ORIGINATION FORM Proposed Revisions to a Design Standards Index (Please provide all information – Incomplete forms will be returned) **Contact Information: Design Standards:** Index Number: 11200 Date: April 26, 2017 Originator: Ed Cashman Sheet Number (s): 1 and 3 Index Title: MULTI-COLUMN GROUND SIGN Phone: (850) 414-4314 Email: edward.cashman@dot.state.fl.us Summary of the changes: Sheet 1: Deleted "8'0" (Max.)" from travel way to sign panel dimension; Added "7'0" (Min.)" for sign post length; Clarified Note 3.C and 3.D. Sheet3: Clarified the callouts for bolt type in the SIGN PANEL SPLICE and in DETAIL 'A'. Commentary / Background: These changes are being made to address sign posts, particularly on backslopes, that are too short and will prevent the breakaway from properly working. Other Affected Offices / Documents: (Provide name of responsible personnel) Yes No ✓ Other Design Standards – ✓ Plans Preparation Manual – ✓ Basis of Estimates Manual –

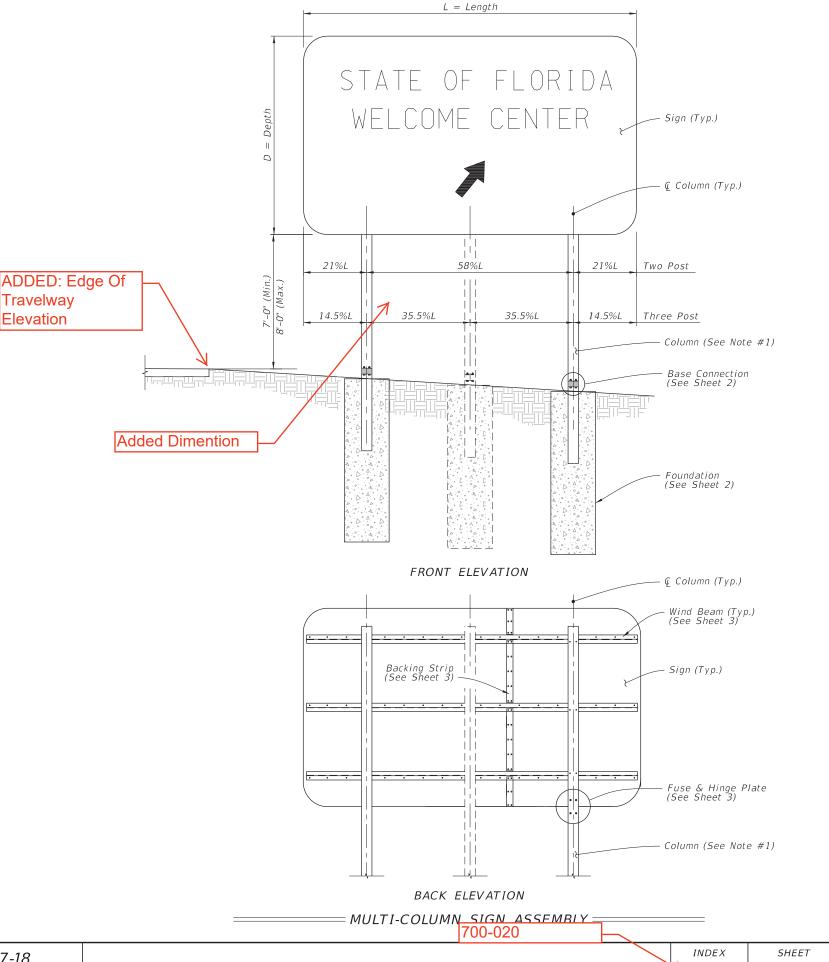
Deleted

- E. High Strength (H.S.) Steel Bolts, Nuts and Washers: a. Galvanized Hex Head Bolts: ASTM F3125, Grade A325, Type 1
 - b. Galvanized Nuts: ASTM A563 Hex, Grade DH
- c. Galvanized Washers: ASTM F436 F. Concrete: Class I.
